SERVICE BULLETIN

SPECIAL INSPECTION TO INCREASE THE TBO FOR ROTAX® ENGINE TYPE 912 (SERIES) SB-912-005UL

SERVICE BULLETIN

SPECIAL INSPECTION TO INCREASE THE TBO FOR ROTAX® ENGINE TYPE 912 A (SERIES) SB-912-005 R3

Fig. 1
Friction washer

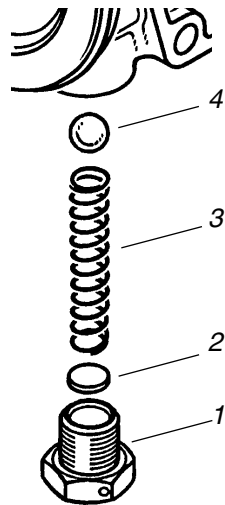
If hex. nut is still secured by a lock washer, it has to be exchanged for the friction washer (1) according to current Maintenance Manual (Heavy Maintenance).

Fig. 2
Improved oil pressure control

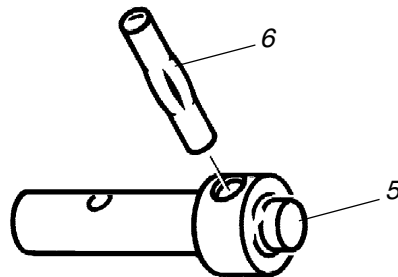
From engine S/N 4,005.186 onwards, to improve oil pressure control the following parameters of the relief valve were changed. Free length of the compression spring (3) was reduced from 46 mm (1.81 in.) to 39 mm (1.55 in.). Spring rate was changed by increase of wire dia. from 0,8 mm (.031 in.) to 0,9 mm (.035 in.), and dia. of ball was increased from 8 mm (.31 in.) to 8,5 mm (.33 in.). If existing, remove shim (4), but if specified oil pressure can't be reached, adjust pressure by adding shim again.

Fig. 3
Oil pump shaft

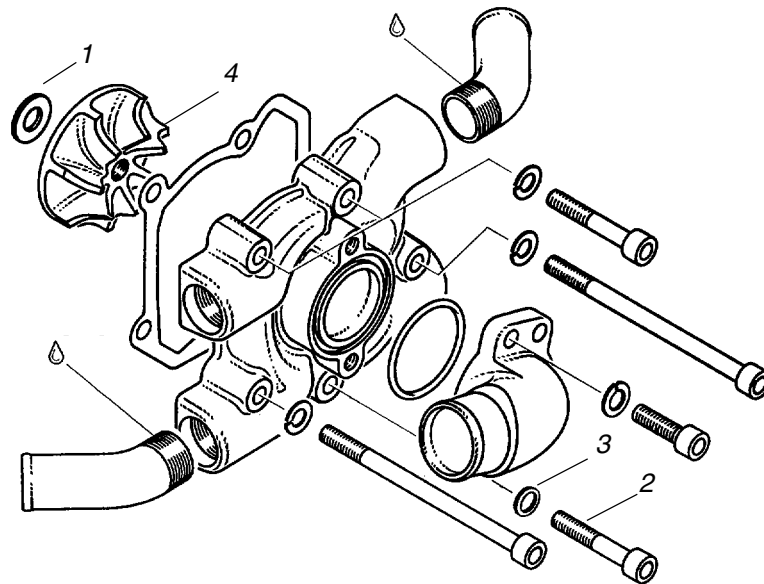
From engine S/N 4,152.101 onward the follower in the oil pump shaft (6) was changed to notched pin (5) instead of the former dowel tube.

At a renewal of components change oil pump to the version with the 16 mm (.63 in.) long rotors.

Fig. 4
Water pump

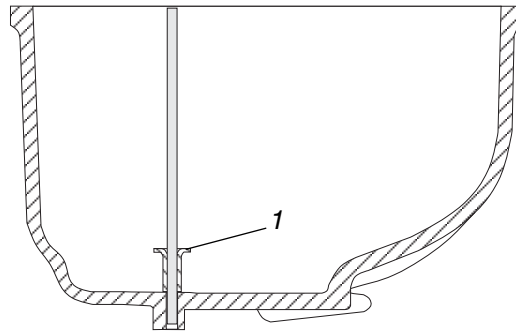
Operation of the engine without antifreeze in the coolant is not permitted since increased formation of corrosion. Therefore the material of the pump shaft was changed with engine S/N 4,152.414. Because of galvanic reactions, caused by the use of various materials, the washer (1) and the screw (2) are of stainless steel since engine S/N 4,152.607.

Fig. 5
Check of float chamber

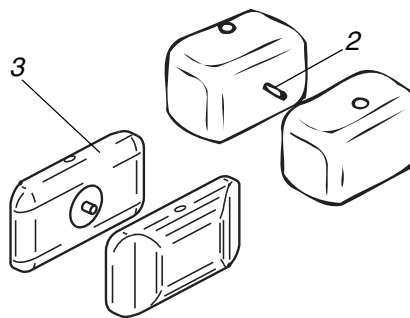
Remove float chamber and lift out both floats. If float chamber is still without distance pieces (1), part no. 861920, add them now, thus avoiding possible sticking of the floats in the float chamber.

Fig. 1
Friction washer

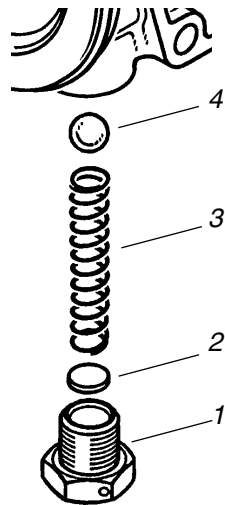
If hex. nut is still secured by a lock washer, it has to be exchanged for the friction washer (1) according to current Maintenance Manual (Heavy Maintenance).

Fig. 2
Improved oil pressure control

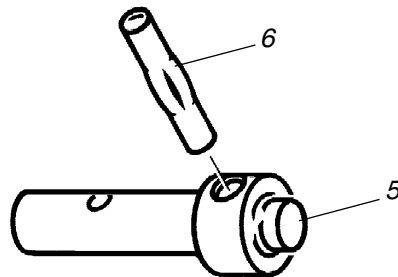
From engine S/N 4,005.186 onwards, to improve oil pressure control the following parameters of the relief valve were changed. Free length of the compression spring (3) was reduced from 46 mm (1.81 in.) to 39 mm (1.55 in.). Spring rate was changed by increase of wire dia. from 0,8 mm (.031 in.) to 0,9 mm (.035 in.), and dia. of ball was increased from 8 mm (.31 in.) to 8,5 mm (.33 in.). If existing, remove shim (4), but if specified oil pressure can't be reached, adjust pressure by adding shim again.

Fig. 3
Oil pump shaft

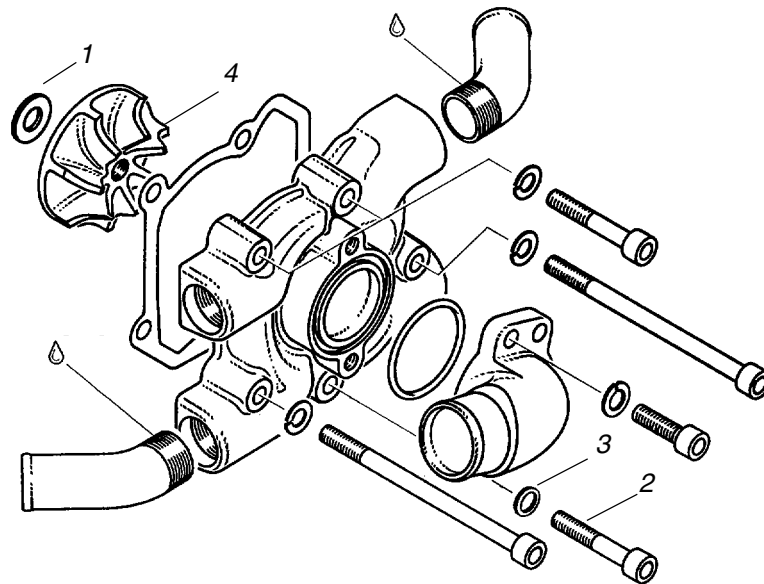
From engine S/N 4,076.068 onward the follower in the oil pump shaft (6) was changed to notched pin (5) instead of the former dowel tube.

At a renewal of components change oil pump to the version with the 16 mm (.63 in.) long rotors.

Fig. 4
Water pump

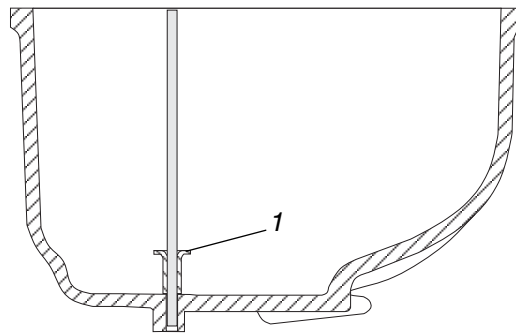
Operation of the engine without antifreeze in the coolant is not permitted since increased formation of corrosion. Therefore the material of the pump shaft was changed with engine S/N 4,076.122. Because of galvanic reactions, caused by the use of various materials, the washer (1) and the screw (2) are of stainless steel since engine S/N 4,076.178.

Fig. 5
Check of float chamber

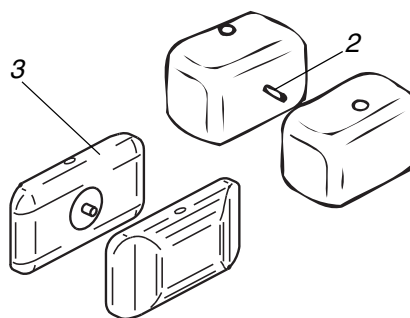
Remove float chamber and lift out both floats. If float chamber is still without distance pieces (1), part no. 861920, add them now, thus avoiding possible sticking of the floats in the float chamber.
